**Meeting Between the U.S. Nuclear  
Regulatory Commission Staff and the  
Nuclear Energy Institute to Discuss  
Current License Renewal Topics**

**September 15, 2016**

# Change in J-R Curves with Different Time at Temperature for CF8M with 23% Ferrite

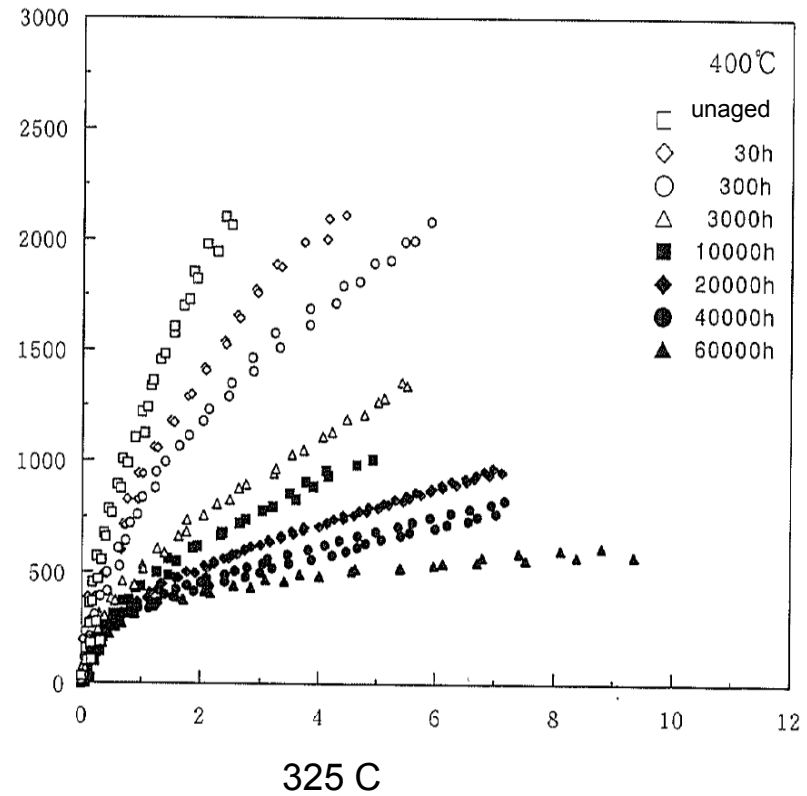
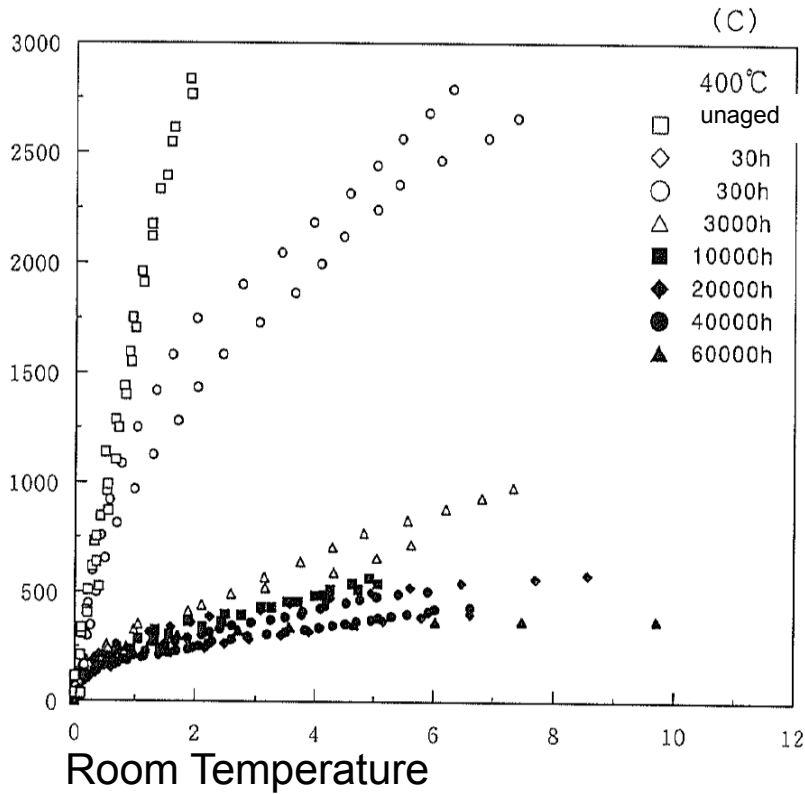
- Although the flaw tolerance evaluation was dropped by ASME Code, it was part of NRC's basis for exempting pump casings in AMP XI.M12.
- Industry provided some information on flaw tolerance evaluations, but the information is only applicable to Westinghouse-design PWRs.
- Industry has not comprehensively demonstrated that all pump casing flaw tolerance evaluations would remain applicable for 80 years.
  - Main issue is whether "saturated" properties for 40 years are really saturated for 80 years.
  - Do generic or plant-specific flaw tolerance evaluations for other vendors (CE, B&W) have similar results and large margins?
- Some pump casings are high molybdenum and ferrite 14% or greater CASS thus TE could be significant, would not meet screening criteria
- ASME Code requirements alone are not always considered sufficient for aging management.

- NRC proposed modification is:
  - For pump casings, as an alternative to the screening and other actions [recommended by AMP XI.M12], no further actions are needed if applicants demonstrate that the original flaw tolerance evaluation performed as part of Code Case N-481 implementation remains bounding and applicable for the SLR period, or this evaluation is revised to be applicable to 80 years.
- In lieu of the above, applicants may choose to perform the screening process for significance of thermal aging embrittlement.
